ADDRESS : 88095 \*UNASSIGNED  
CONTRACTOR : POPE JEFFREY LYNN  
OWNER : ANDERSON HARRY L & ETHELYN M  
PARCEL : 12-0548- - -0016- -60-  
APPL NUMBER: 08-50019682 CP NEW RESIDENTIAL (SFD)

Addendum No. 1 Date: 6-4-08

Project: ANDERSON RES.

The Proposed Design Drawings For This Project Are Modified as Follows:

FOUNDATION PLAN:

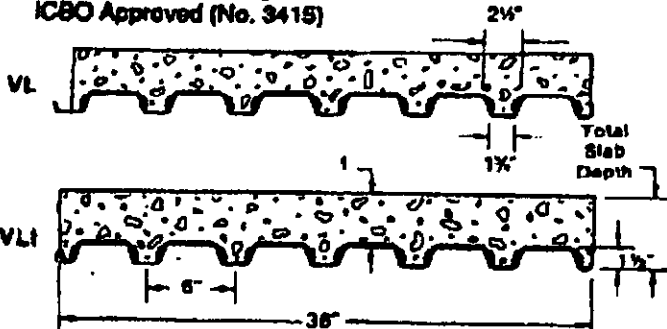
THE PORCH AREA PIERS & ANGLE SUPPORT STEEL MAY BE CHANGED TO HEAVY GAUGE METAL DECKING SPANING ACROSS THE SHORT WAY OF 7'-0" CLEAR SPAN.

BASED ON THE ATTACHED VULCRAFT LOAD TABLE FOR 4" SLAB THICKNESS THE REQ'D DECK TYPE 1.5 VL 20. BEARING LENGTH 2" MIN.
